Addendum No. 2

Project Number: H59-N275-CB

Project Name: HGTC - Grand Strand Campus BDG 100 Parking Lot

SHEET NUMBER:
C2.0

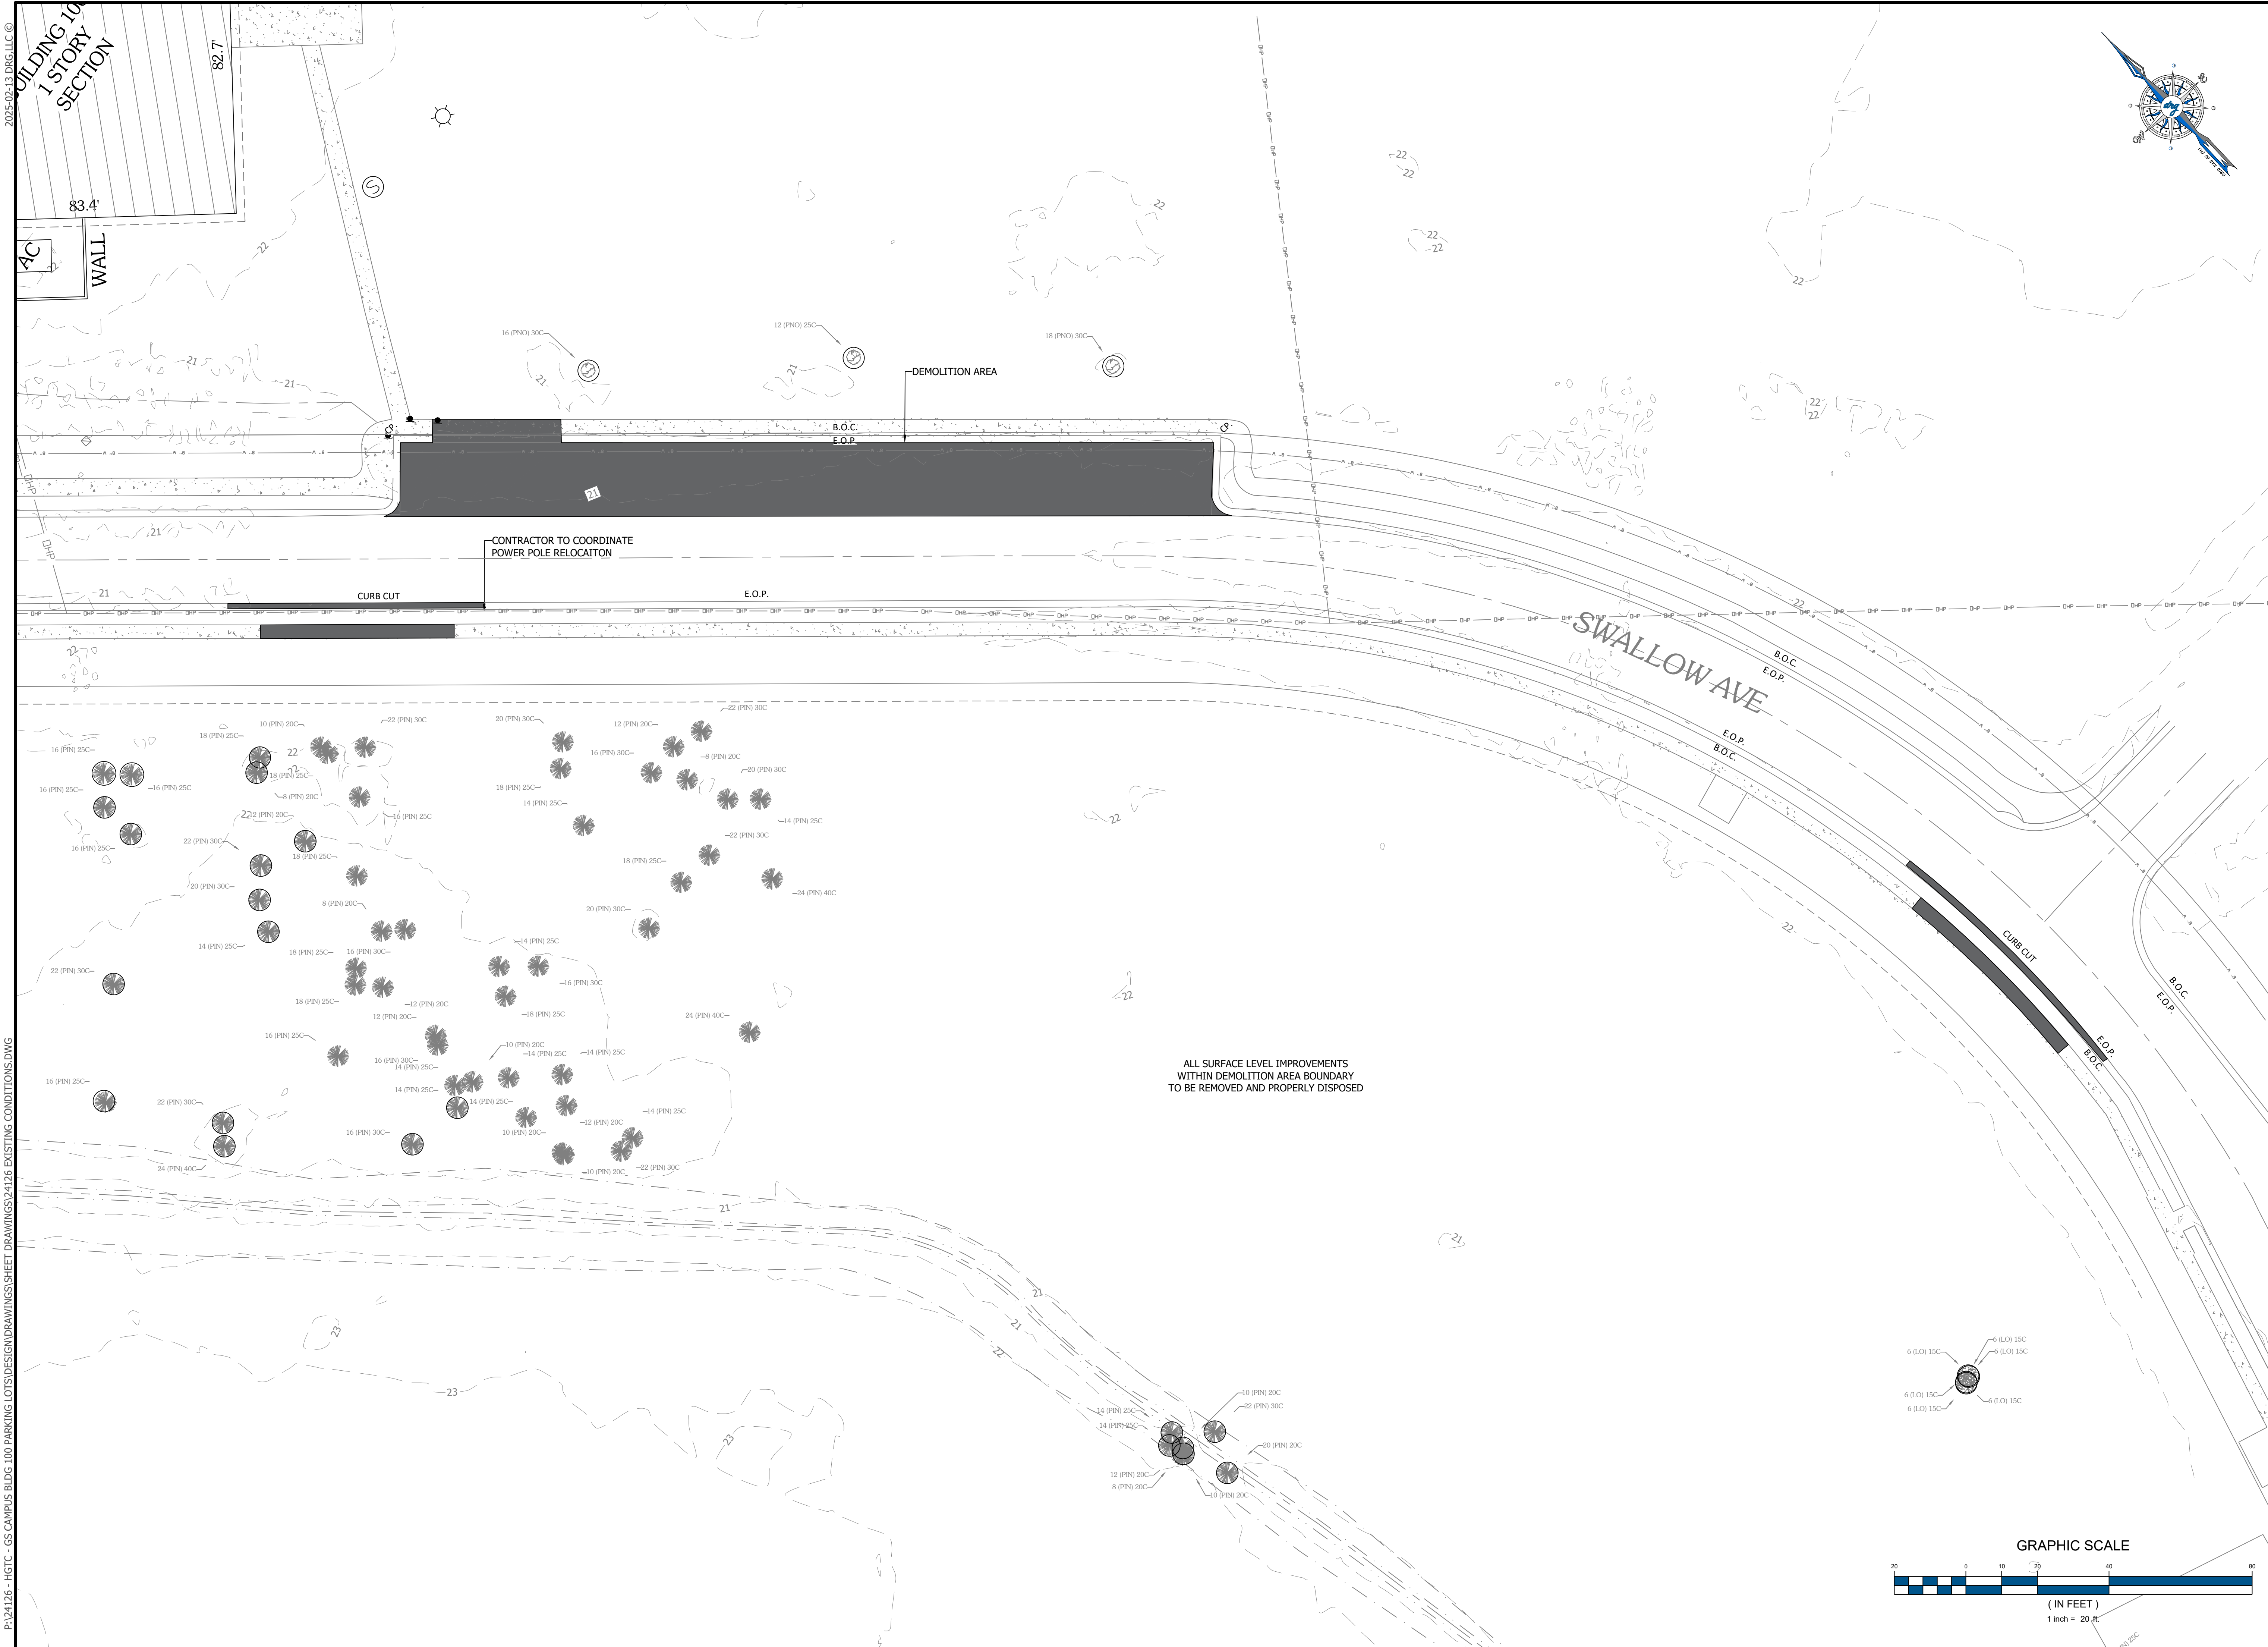
1. Sheet C2.0:
Clarified demolition areas.
2. Sheet C3.0
Clarified replacement curb, sidewalk, and ramp notes in the vicinity of demolished areas.
3. Sheet C4.0:
Clarified underdrain location.
